FINAL UNEXPLODED ORDNANCE 16 (UXO 16) WIDE AREA ASSESSMENT WORK PLAN  
ATLANTIC FLEET WEAPONS TRAINING AREA FORMER NAVAL AMMUNITION SUPPORT  
DETACHMENT AND FORMER VIEQUES NAVAL TRAINING RANGE VIEQUES ISLAND  
PUERTO RICO  
12/01/2015  
CH2M HILL

**UXO 16 Wide Area Assessment Work Plan  
Atlantic Fleet Weapons Training Area - Vieques  
Former Naval Ammunition Support Detachment and  
Former Vieques Naval Training Range  
Vieques, Puerto Rico**

**Contract Task Order 005**

**December 2015**

**Figure 1-4**  
**Previous Underwater Investigations at the Former VNTR**  
*Underwater Wide Area Assessment Work Plan*  
*Former VNTR*  
*Vieques, Puerto Rico*

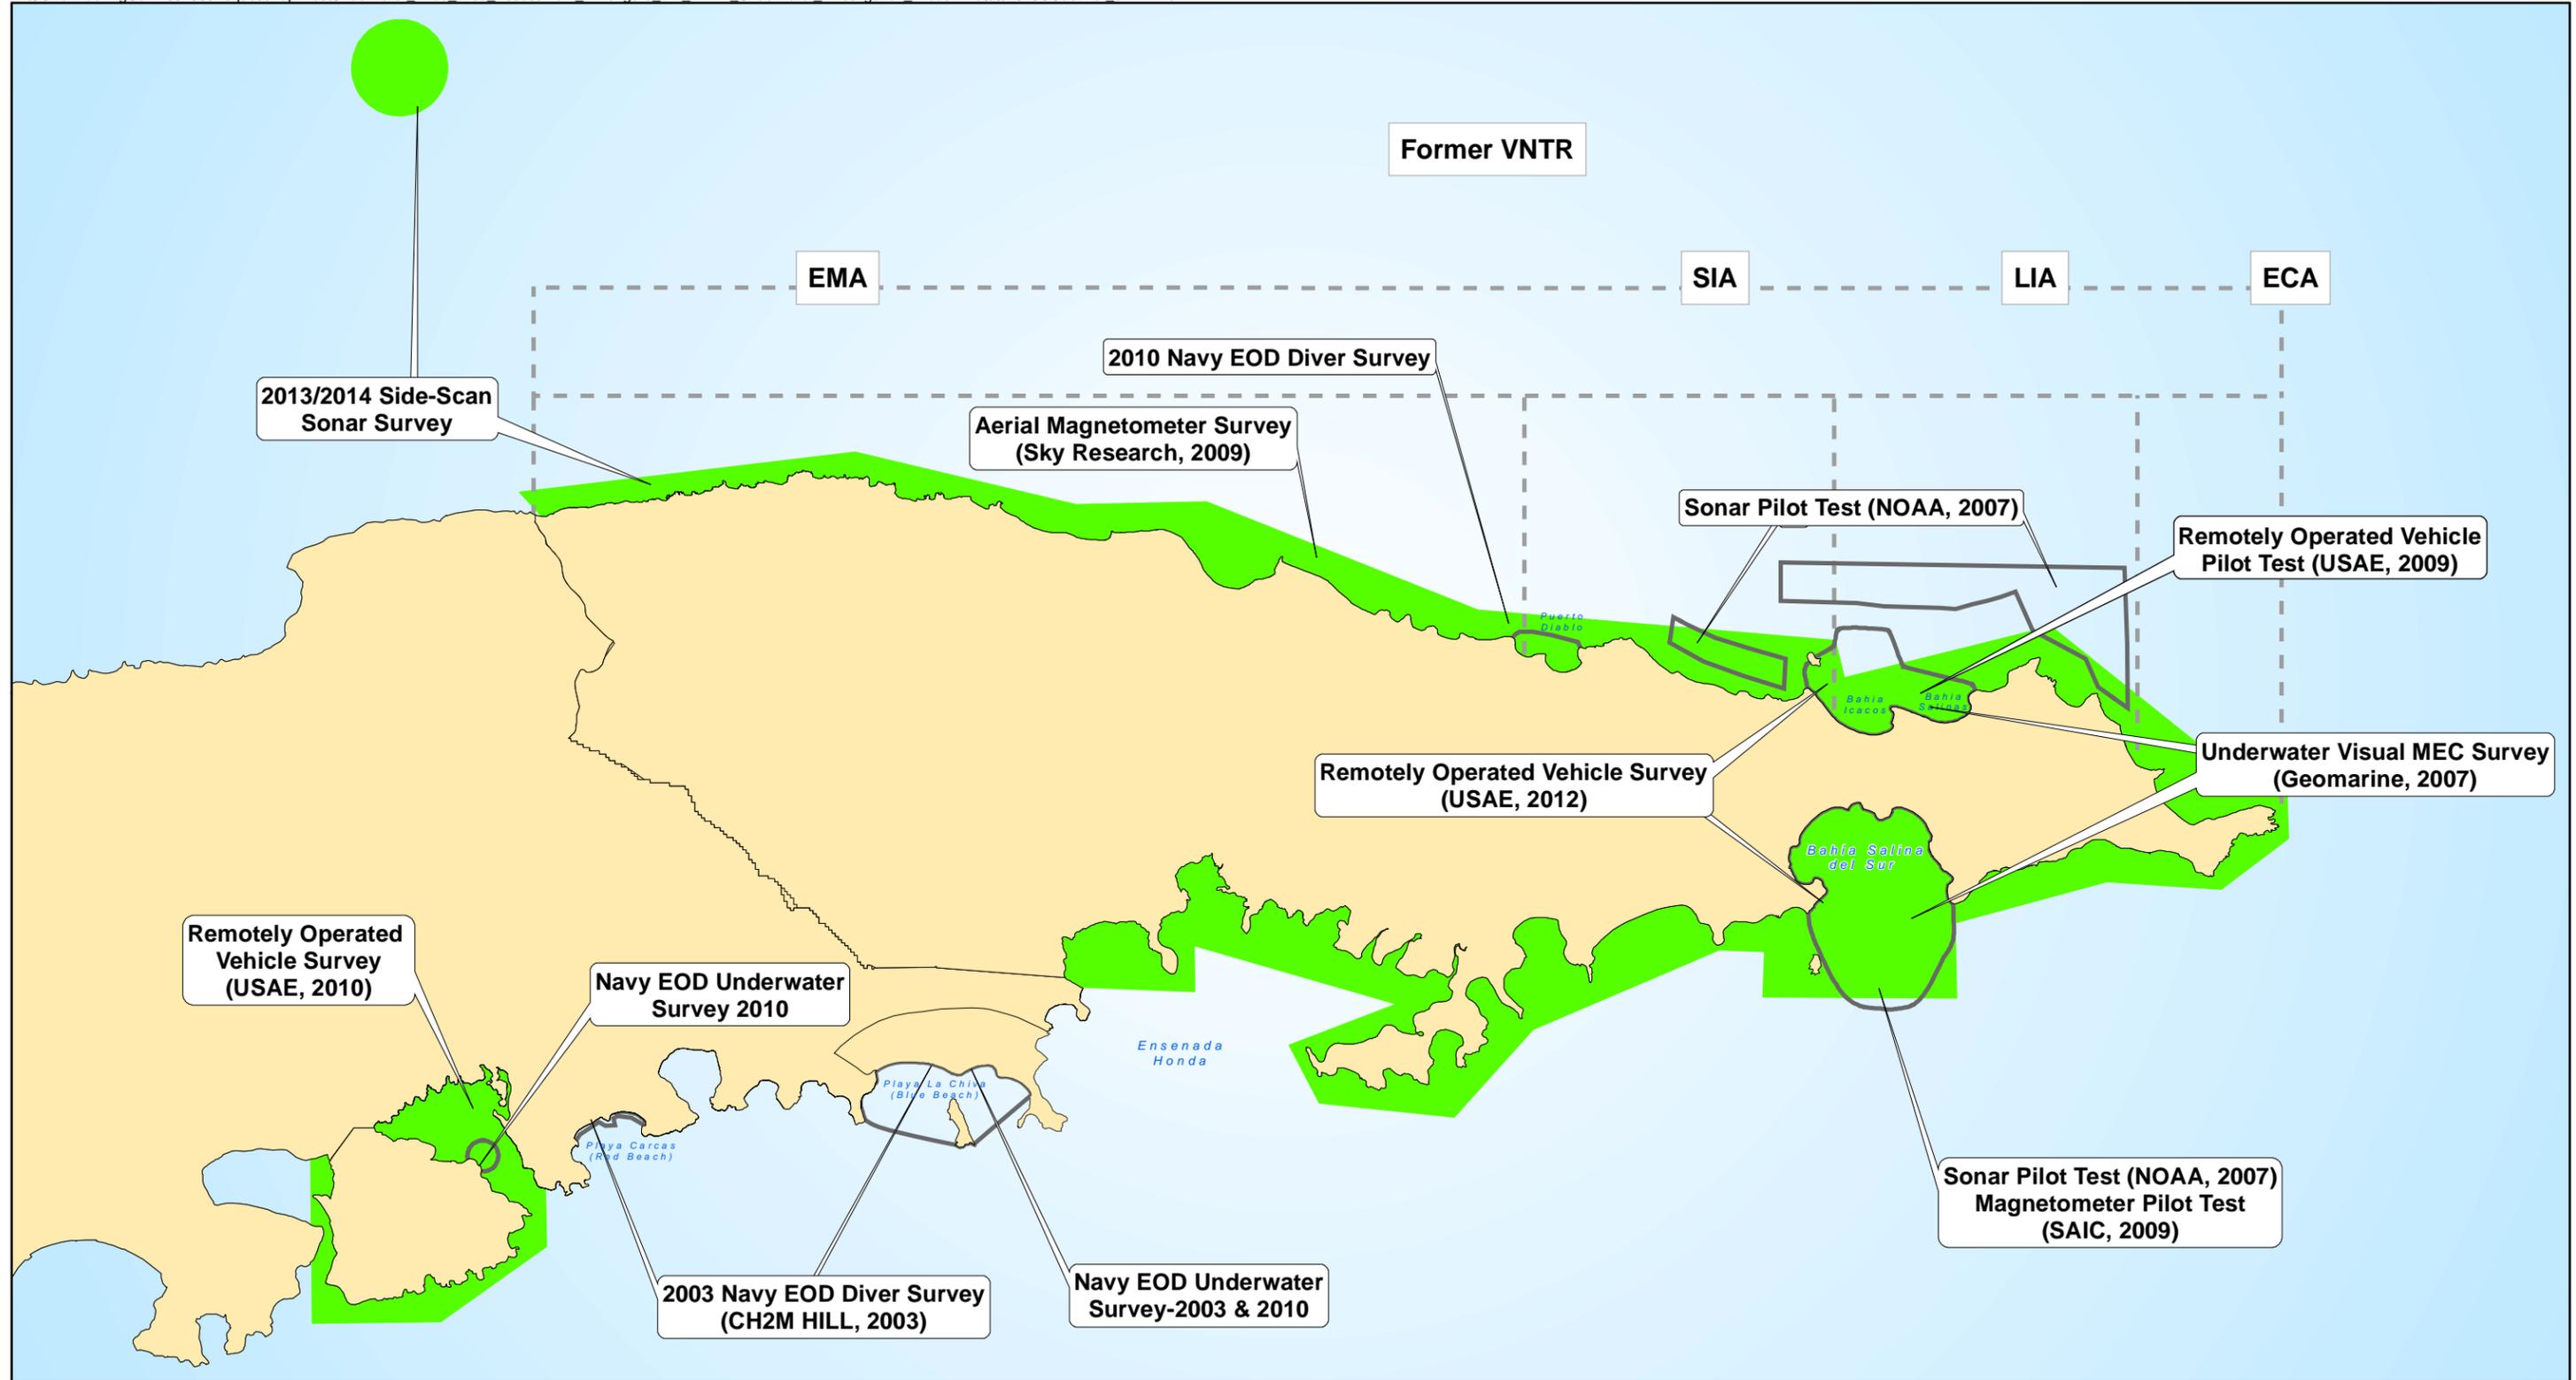
5. Information presented in Section 1.2, Previous Investigations, is not consistently presented on Figure 1-4, Previous Underwater Investigations at the Former VNTR, including but not limited to:
  - Bahia Icacos is not labeled on Figure 1-4 as stated in the first paragraph of Section 1.2.1, Side Scan Sonar Pilot Test and Underwater Magnetometer Survey.
  - Puerto Diablo is not labeled on Figure 1-4 as stated in Section 1.2.4, Navy Explosive Ordnance Disposal (EOD) Diver Surveys.

Revise Figure 1-4 to include labels for all of the locations discussed in Section 1.2.

**Navy Response:** Figure 1-4 has been modified to include location labels for sites discussed in Section 1.2.

**Navy Response:** Figure 1-4 has been modified to identify the 2009 ROV pilot test location, which is now labeled as “Remotely Operated Vehicle Pilot Test (USAE, 2009).”

**FIGURE 3-1**  
 Signal to Noise Ratio Curves for Magnetometers and EM61-MK2 Sensors  
*Underwater Wide Area Assessment Work Plan*  
*Former VNTR*  
*Vieques, Puerto Rico*

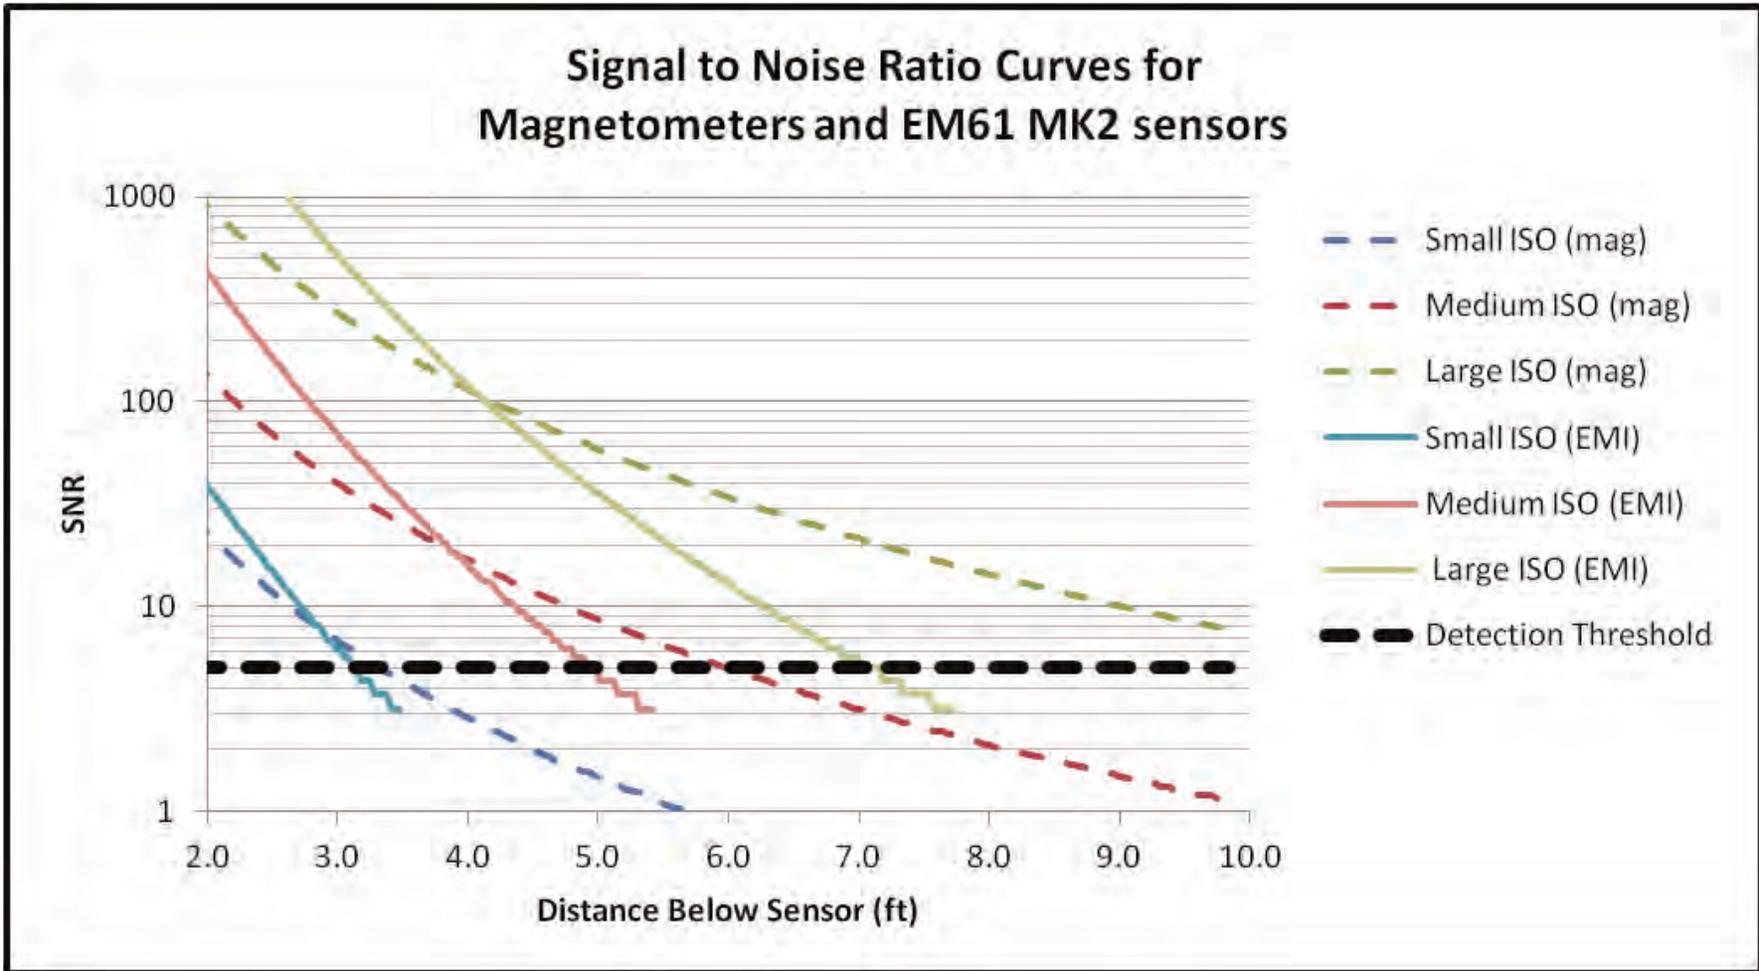
7. Results plotted in **Figures 3-1, Signal to Noise Ratio Curves for Magnetometers and EM61-MK2 Sensors,** and **Figure 3-5, Minimum Expected Total Magnetic Field Response,** are hypothetical based upon certain assumptions. Are those assumptions tenable for the UXO 16 underwater investigation?

- Figures 3-1 and 3-5 indicate that MEC the size of small ISOs (approximately the size of a 20-mm projectile) will not be detected at the planned sensor deployment height indicating that small MC fragments will not be detected.

**Navy Response:** Figure 3-1 is intended only to depict the difference in performance between EMI sensors and magnetometers (thus the use of SNR to allow comparison). The following text has been added to Section 3.1 for clarification: “The noise assumptions for the data presented on this figure are consistent with terrestrial deployment (1 nT for the magnetometer and 0.5 mV for the EMI sensor). While it is anticipated that the SNR performance will improve slightly in the marine environment, this improvement will occur with both systems and the comparison between the systems remains valid.” The data presented in Figure 3-5 are derived from test stand measurements and are reasonable for the study objectives.

**Navy Response:** Small ISOs are similar in size to 37mm projectiles. As shown on Figure 3-1 and Figure 3-5, items of this size will not be reliably detected during the WAA (although some items of this size may be detected). The intent of the WAA is to not to identify small munitions fragments, but instead to identify elevated anomaly density areas, as stated in the second paragraph of Section 1.

FIGURE 3-4  
Visual Sample Plan (VSP) Results  
Underwater Wide Area Assessment Work Plan  
Former VNTR  
Vieques, Puerto Rico

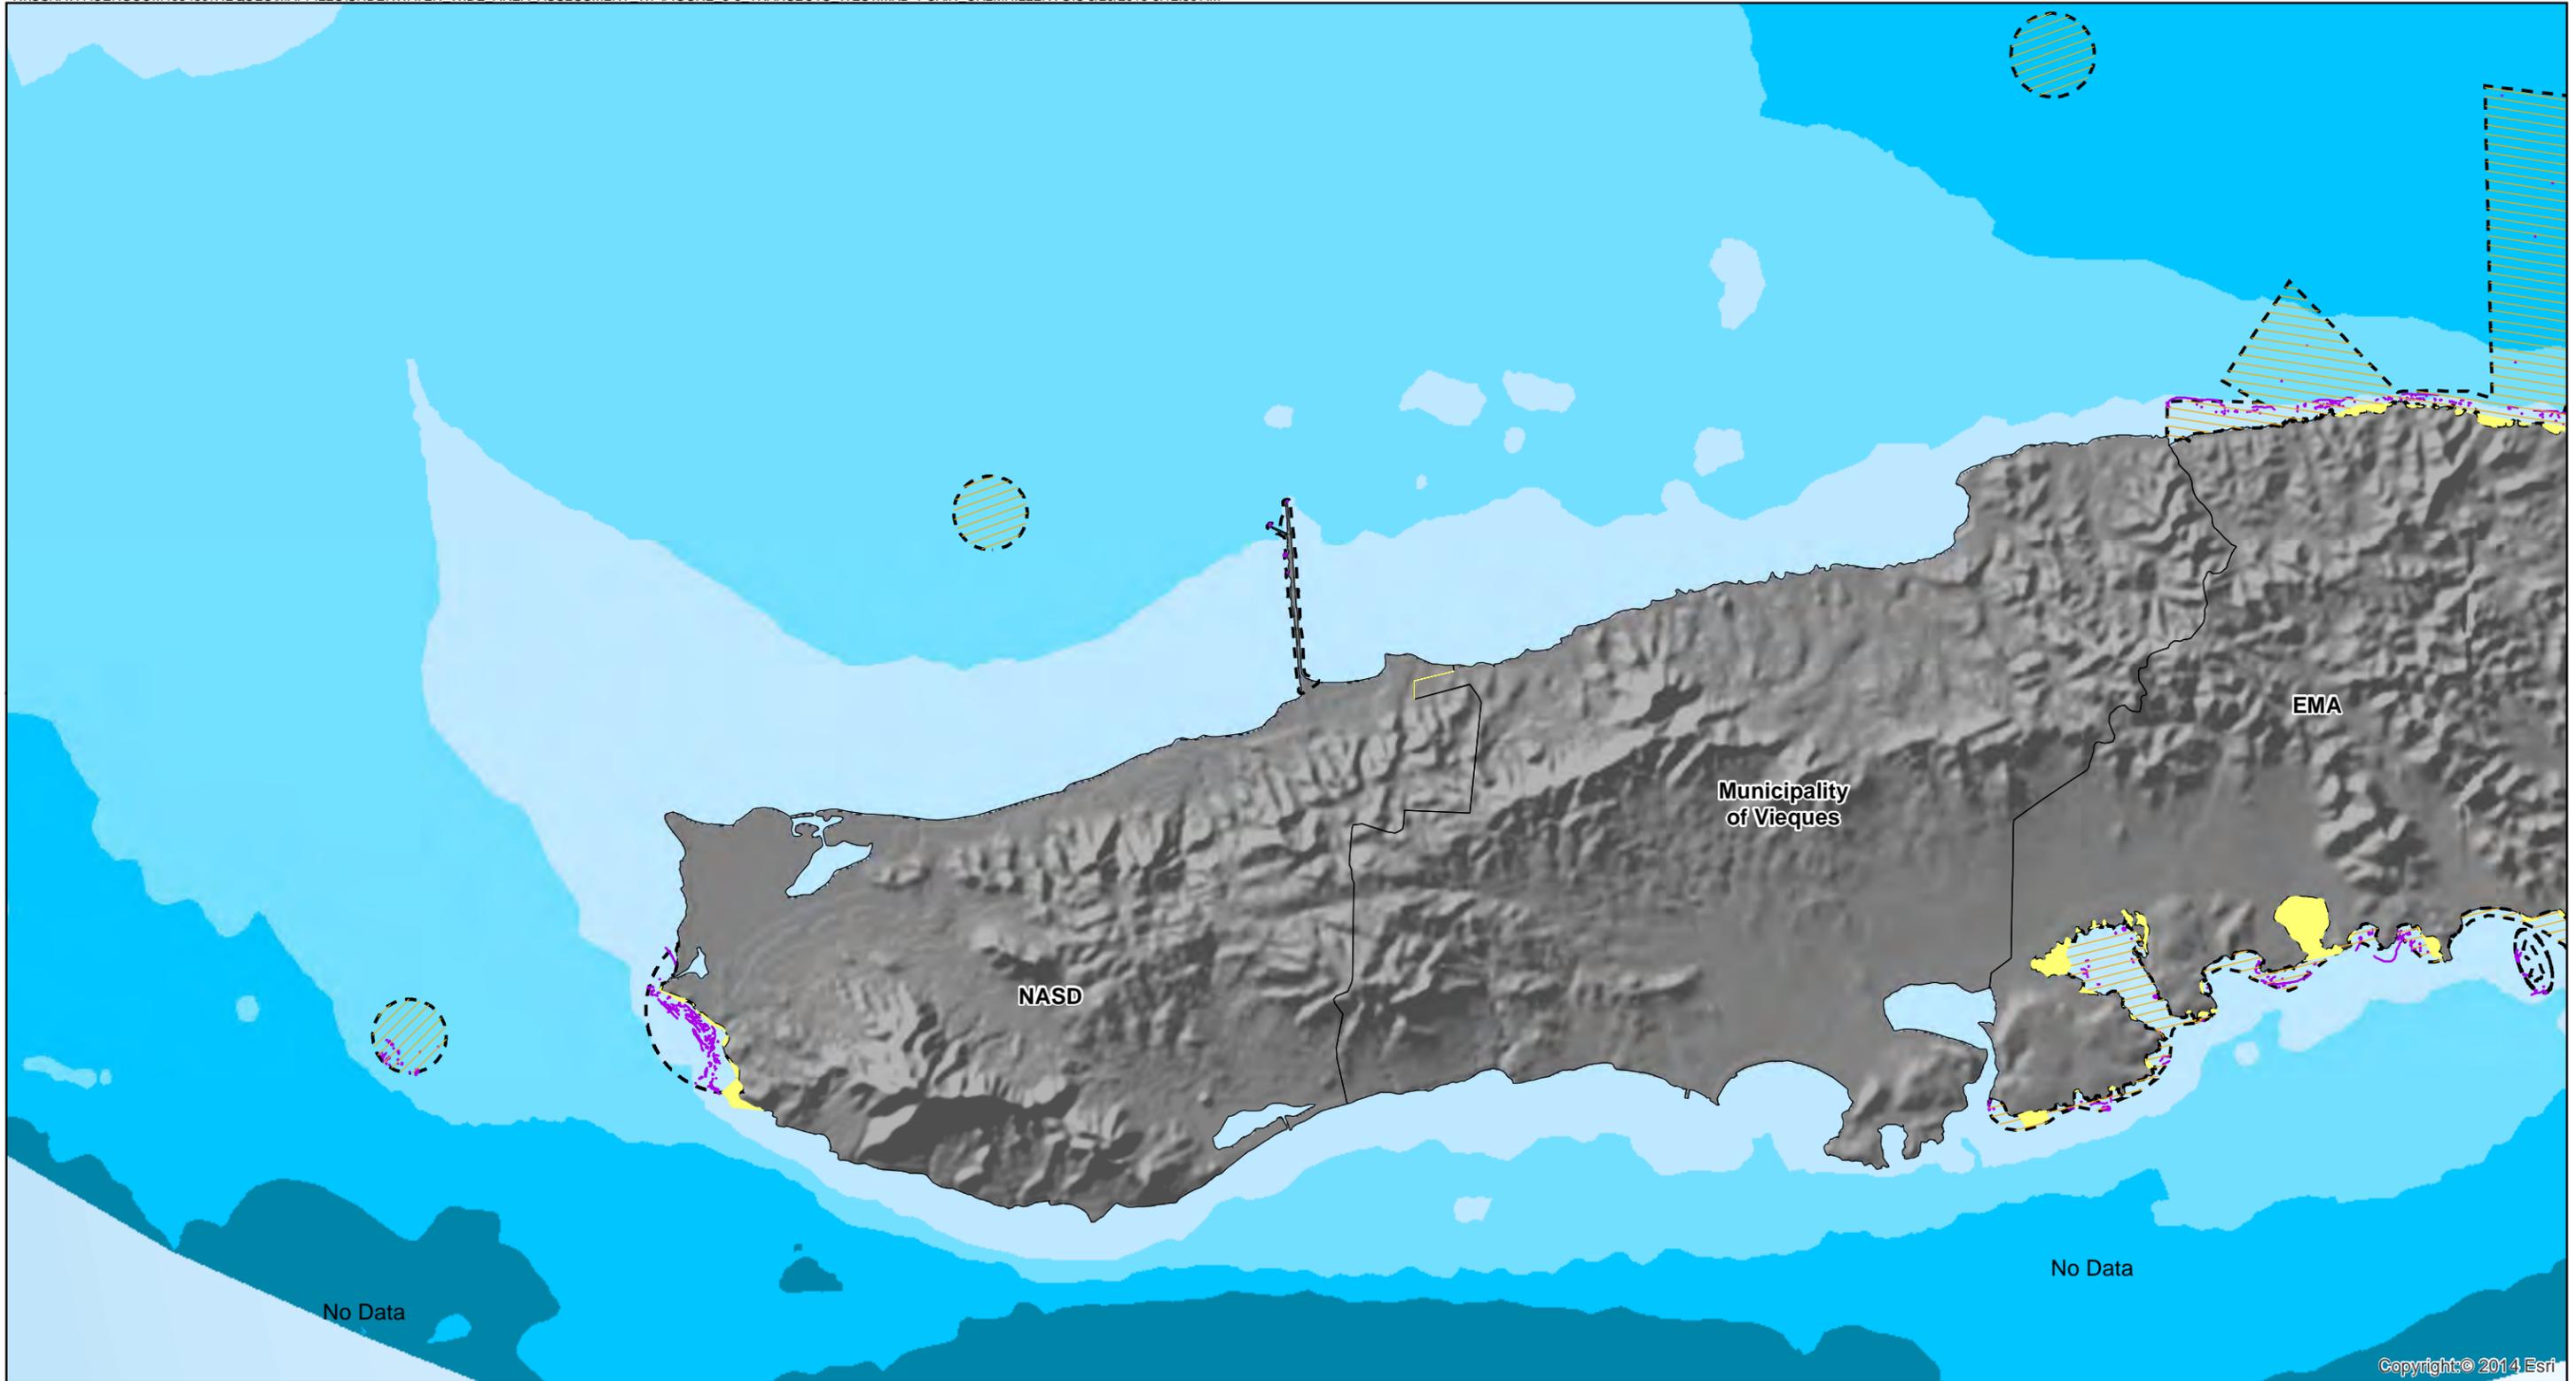
**EPA Response:** The response partially addresses the comment. The response states that Visual Sampling Plan (VSP) does not produce a report. However, a VSP report can be produced by choosing “View” and “Report.” This report along with Figure 3-4 should be provided in the Draft Work Plan. Revise the Draft Work Plan to provide the VSP report.

**Navy Response:** VSP does not produce a report summarizing the evaluation results, but the results of the VSP evaluation are presented in Figure 3-4. Additionally Figure 3-4 has been updated to include the VSP version, module, and input parameters used for UXO 16.
